REGULAR OPEN MEETING OF THE UNITED LAGUNA WOODS MUTUAL ARCHITECTURAL CONTROL AND STANDARDS COMMITTEE*

DATE: March 21, 2024
FOR: Architectural Control and Standards Committee
SUBJECT: Revision to Standard 22: Patio Slabs

Attachment 3 – Redlined Revised Standard 22: Patio Slabs, Walkways & Pavers

PATIO SLAB SECTION

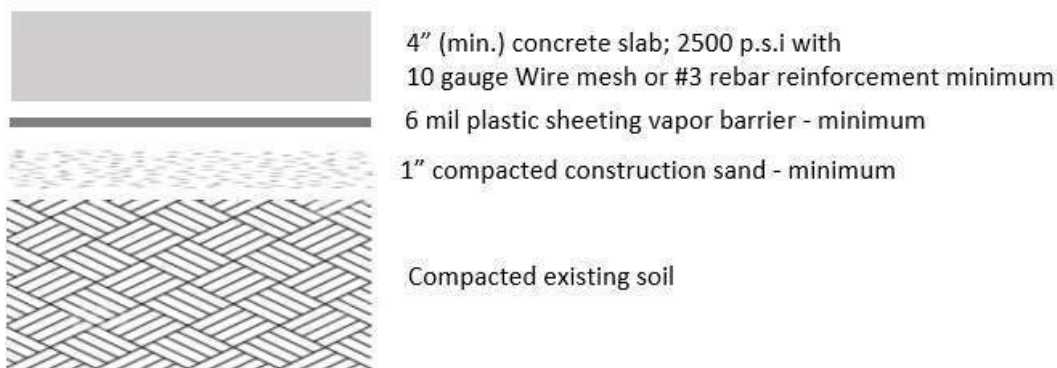
3.7 Concrete slabs

A. If the proposed patio slab is adjoined to an existing slab, a detail of how the slab will be doveled to existing slab must be provided.

B. Concrete slabs to be constructed as per this section detail:

C. Slip resistance finish: For safety considerations, it is recommended that any finish of a concrete slab have a SCOF (Static Coefficient of Friction) of .06 or higher, conforming to established ADA guidelines.
